Oriel Window Regulations

Window projections & the pedestrian experience

Presentation to the Portland Design Commission

May 1, 2025

Eleven West: 1102-1116 SW Washington St

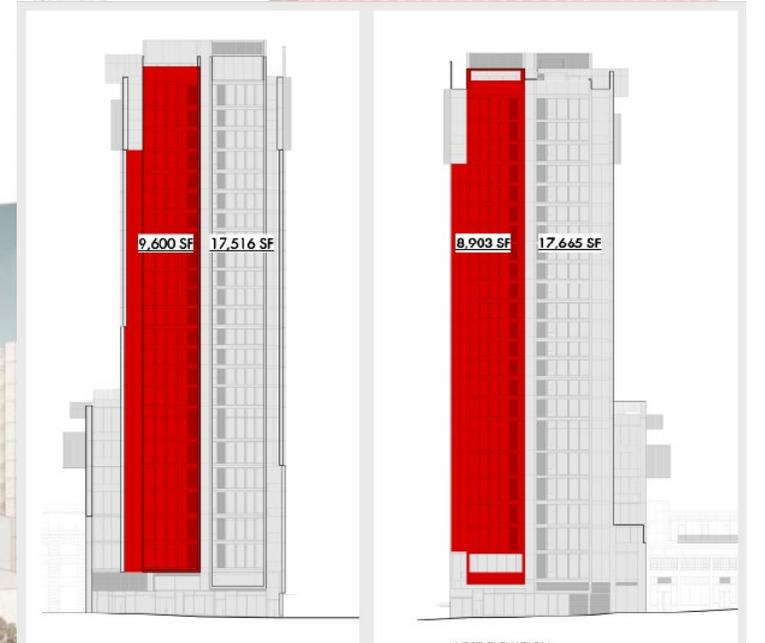
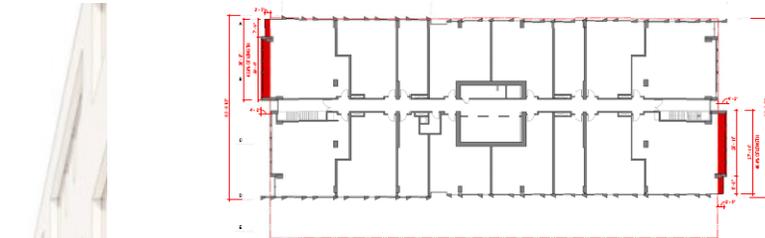
Exception to Window Projections into the Right-of-Way (OSSC/32/#1)

To increase the 12' maximum width of window projections to:

- 36'9" along SW 12th (West Elevation), 37'-11" along SW 11th (East Elevation)
- To not have required side wall windows for projections greater than 2'-6".

BDS & PBOT support

- Better meets DG's C4. Complement the Context of Existing Buildings and C5. Design for Coherency

[D Street Village Apartments, 3233 SE Division](#)

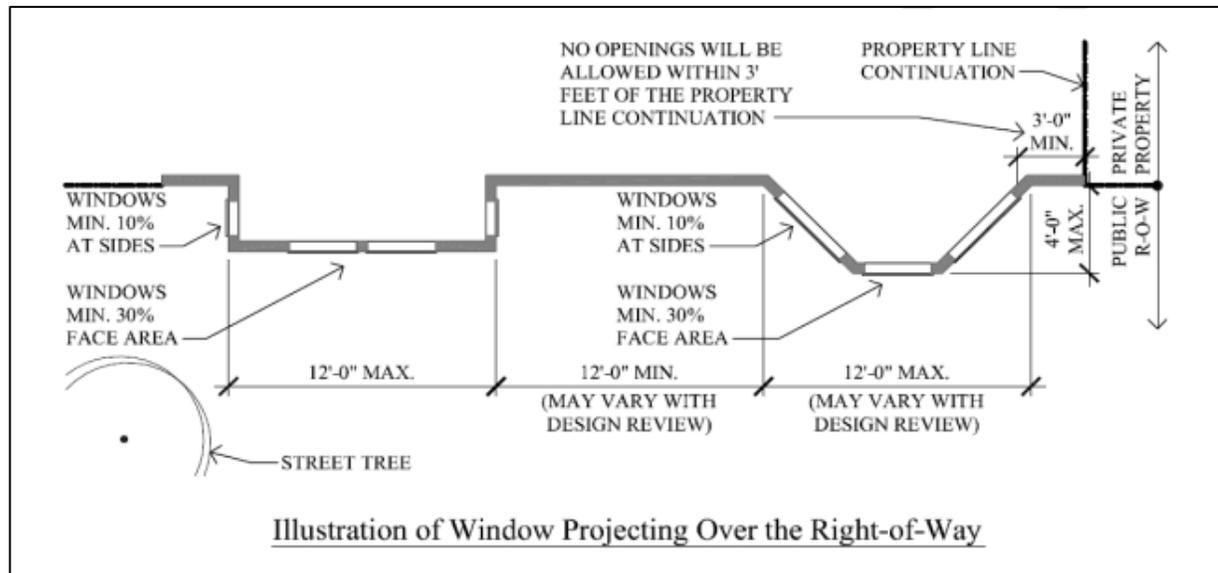
Proposal 1:

Link projection distance to frontage zone width

Existing:

Maximum projection of **4 feet** into the right-of-way

Proposed:

Maximum projection equal to width of **sidewalk frontage zone plus 1.5 feet.**

Minimum of 10 feet from curb face

May not extend beyond 4 feet regardless of frontage zone width.

[The Morgan, 1650 SE Tacoma St.](#)

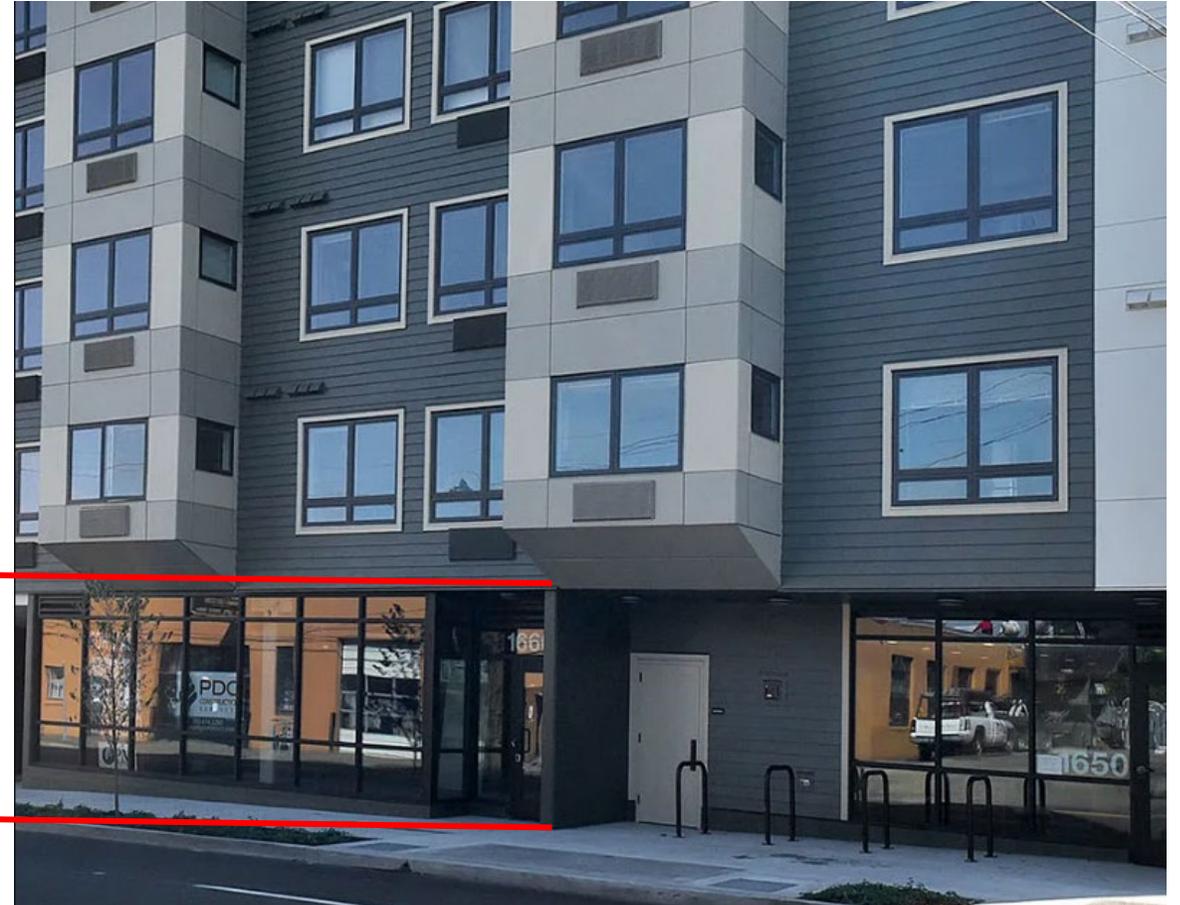
Proposal 2:

Increase minimum height for oriel windows, but not balconies

Existing:

Projections are allowed over **8 feet** above grade, with 1 inch of encroachment allowed for each additional inch of clearance above 8 feet.

Proposed:

Balconies: projections allowed over **8 feet** above grade, with 1 inch of encroachment allowed for each additional inch of clearance above 8 feet.

Oriel windows: projections allowed over **11 feet** above grade, with 1 inch of encroachment allowed for each additional inch of clearance above 11 feet.

[Kearney Plaza, 930 NW 12th Ave](#)

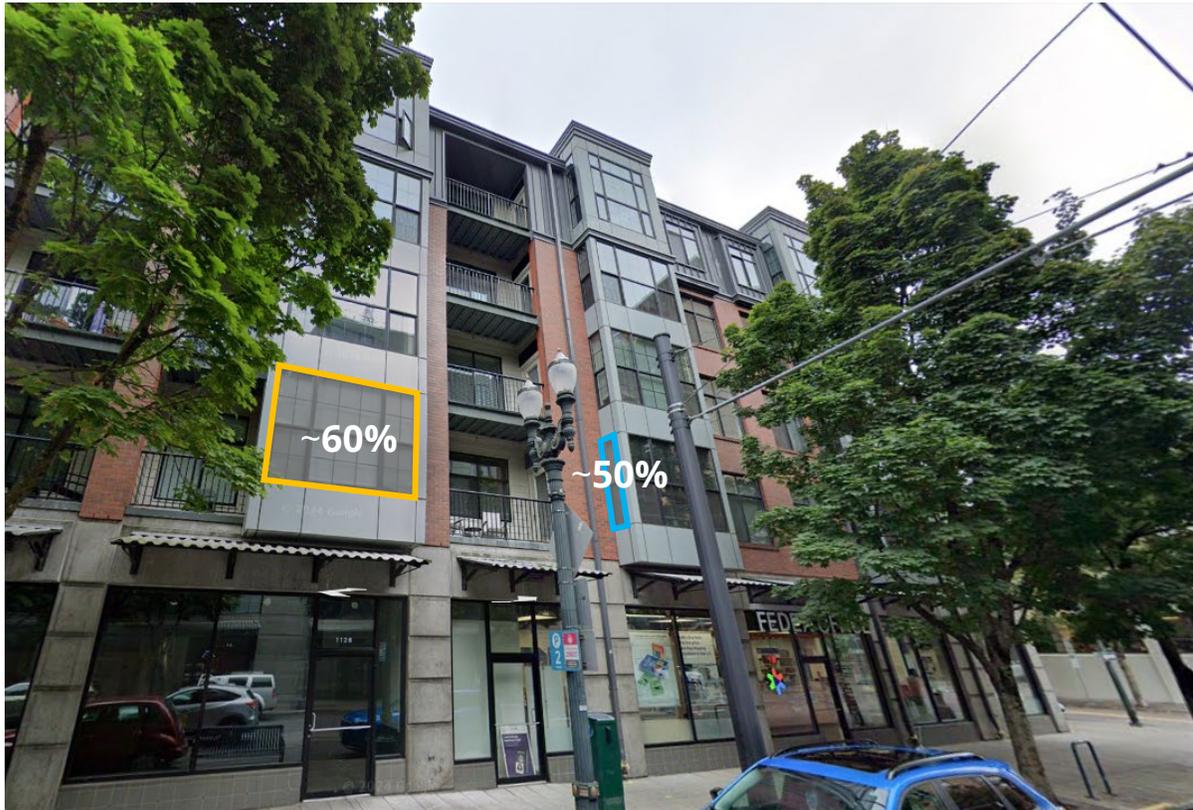
Proposal 3:

Increase proportion of projections that must be windows

Proposed:

The minimum window area at the face of the oriel window projection is **50%**

The minimum window area on side walls of the oriel window projection is **25%** for projections >2.5 feet deep.

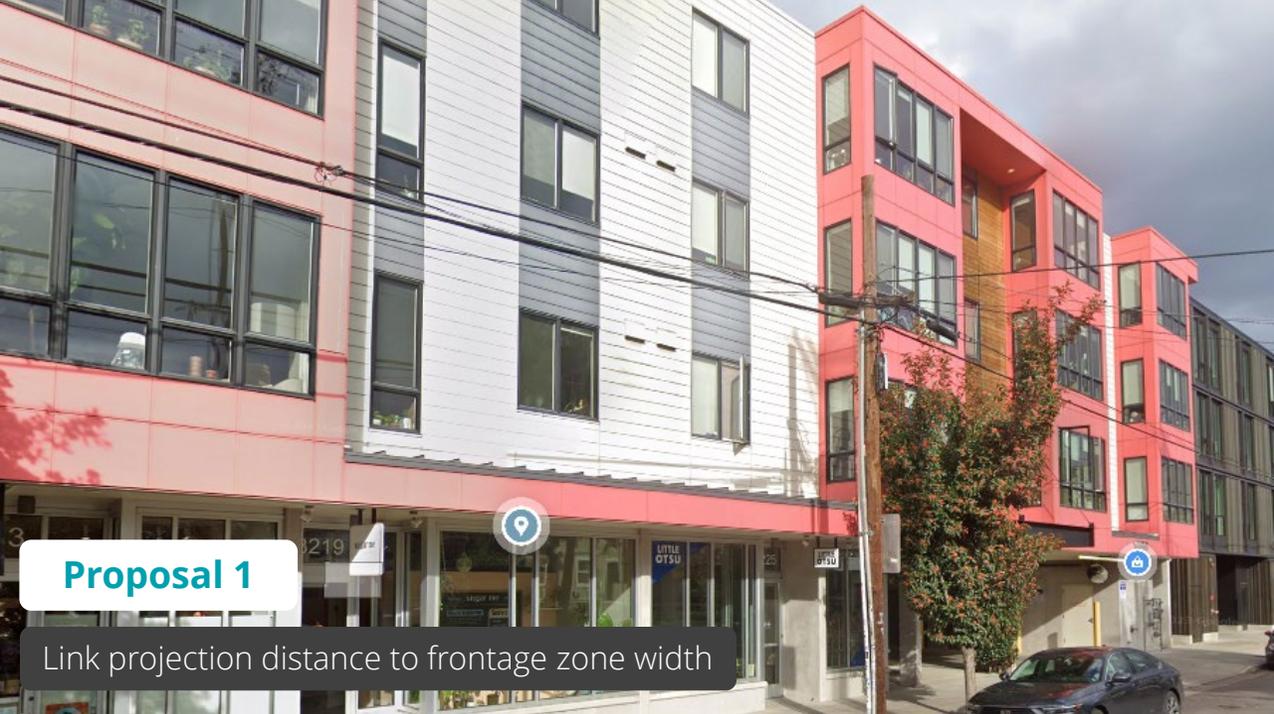
Proposal 4:

Address adjacent balconies and oriel window projections

Existing:

Maximum width of **12 feet** for each projecting window element.*

*the width of balconies is not specifically addressed. They may be placed between oriels without counting toward the projection width.

Why?

Avoid continuous cavernous or tunnel-like streetscapes as re-development occurs.

Proposed:

Maximum width of **12 feet** for each projecting window element. Where a window projection and a balcony are located immediately adjacent to one another, and the floor of such balcony has a minimum horizontal dimension of 6 feet, the maximum width for combined window and balcony projections is increased to **18 feet**.
